## **Application for Mansard Roof Extension at 5 Mornington Place**

**Application no. 2021/0124/P**

### **OBJECTION**

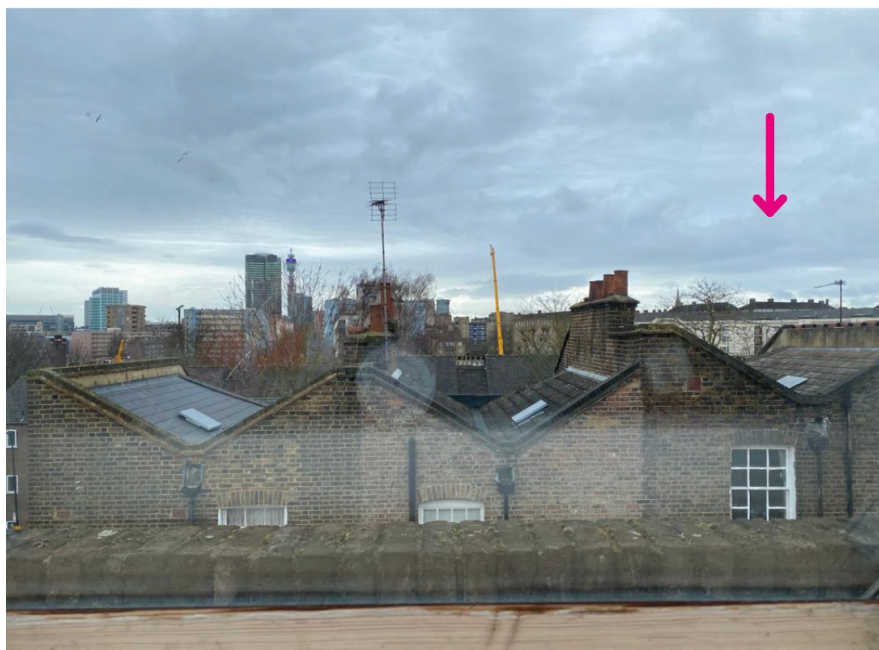
This photo was taken from one of the bedroom windows of our house. No 5 Mornington place is marked by the arrow. (We do have another window 2m to right of the one this was taken from which faces the mansard more directly. Unfortunately, I don't have a picture taken from that window to hand and in my haste to submit these comments, am unable to take one.)

We don’t agree with this assertion. As you’ll see from the photograph, we live in the house to the rear of No.5 Mornington Place that sits adjacent to it. We have two top floor windows which aren’t shown in the architect’s visualisation. The proposed roof extension would create views for its occupants directly into a bedroom less than 8m away. We would clearly be more ‘overlooked’ by the development and our privacy adversely affected.

The extension would mean that our views south over the city would be compromised and we’d lose light from the rooms in the top of the house. Most sad of all though is that the south facing profile view of the valley roofs would, in our view, be ruined forever, not just for us, but to the immediate neighbourhood. That profile, which is visible a block away through the gardens on Mornington St. would be totally dominated by the new mansard.

Our small but much-loved garden would also be directly overlooked by the windows of the new mansard. (We currently have a wall around our rear garden which offers us privacy from the 2<sup>nd</sup> floor of the neighbouring terraces, but wouldn’t offer privacy from a mansard-level viewpoint).

Of greater concern to us though, is the shadow the new mansard would cast over our garden and the loss of sunlight. I gather Camden’s guidance is for developers to seek to preserve their neighbours’ access to daylight and sunlight. I’m afraid this guidance has been overlooked in respect of our home and that of our neighbours.
